This document is the response of the authors to the reviewers comments. It includes a point-by-point response to the reviews and a marked-up manuscript version

Climate Change Impacts on Yangtze River Discharge at the Three Gorges Dam

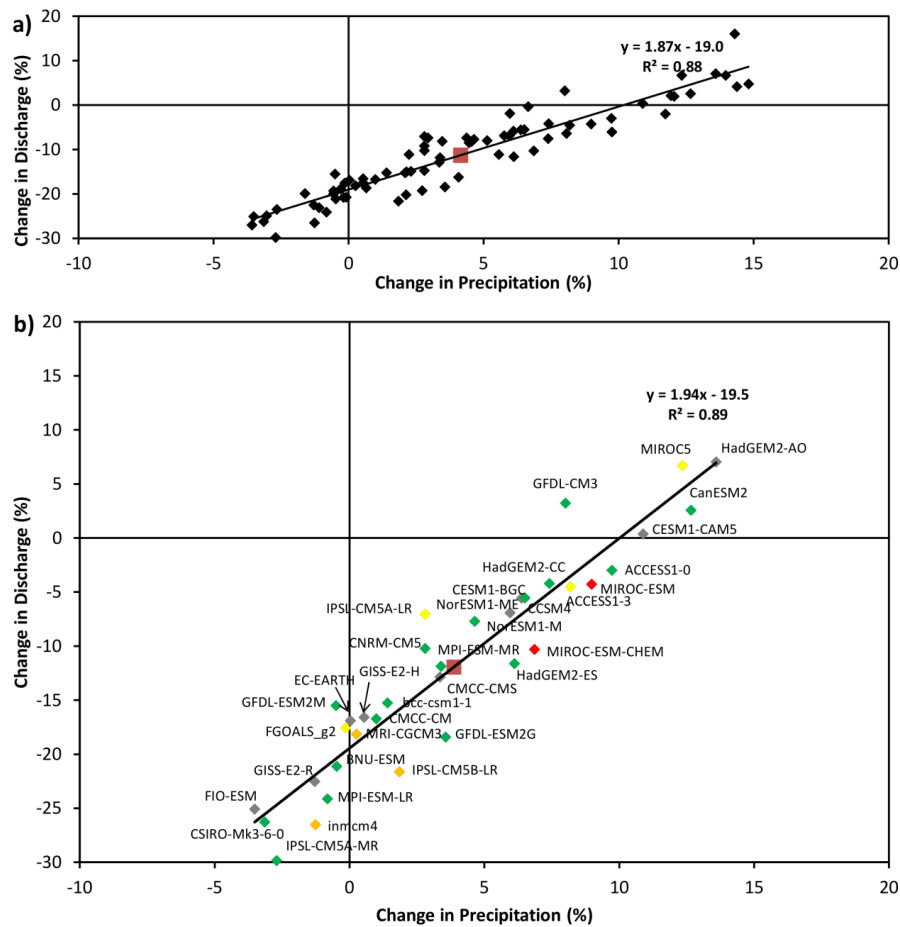
Major comment 3 *“GCM selection. The authors find that the simulations of several variables by the GCMs are “implausible” (Tables 3 and 4), yet they still decide to include those models in the ensemble. I suggest conducting a second evaluation, in which they exclude the climate models that they do not deem realistic. Does it lead to a significantly lower spread of the ensemble of discharge projections? In Figure 10, implausible models fall close to the regression line, but I do not consider this as a proof of realism, since they could well fall there for the wrong reasons.”*

Authors Response: We have considered another evaluation of the effect of the GCMs on discharge in which we exclude the climate models that are not considered to be realistic. The response is very similar to the existing Figure and does not lead to a significantly lower spread of the ensemble of discharge projections. The sentence has been modified: “The ‘satisfactory’ green points cover almost the entire range and so it is very hard to discount any future projections of change in precipitation or discharge (plotting only these points gives a very similar response and does not lead to a significantly lower spread of the ensemble of discharge projections).”

We agree that in Figure 10 if implausible GCMs fall close to the regression line it is not considered as a proof of realism.

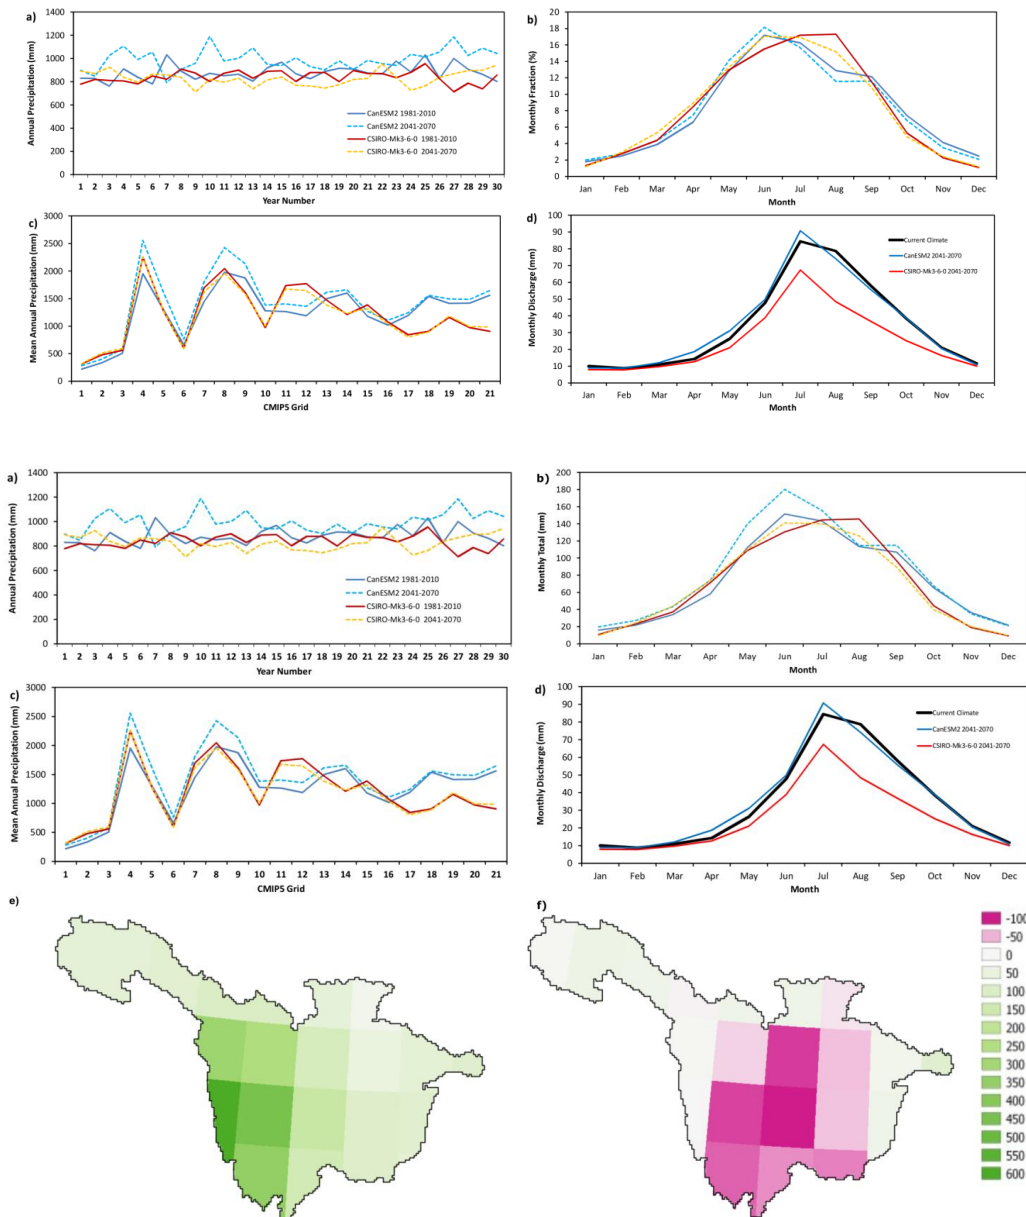
Minor comments 17. *“Figure 11: I find this comparison really interesting, but the discussion would be easier to follow if Figure 11c was replaced by a map showing the differences between the models. As already stated, I am not convinced by the choice of showing the monthly precipitation fraction instead of the monthly means (Figure 11b).”*

Authors Response: We agree with the referee and have changed Figure 11 (now Figure 13) to include parts e) and f) so that
5 it is much easier to see the changes in Figure 11c. As suggested by the referee monthly precipitation totals are now shown in Figure 11b (rather than monthly fractions).
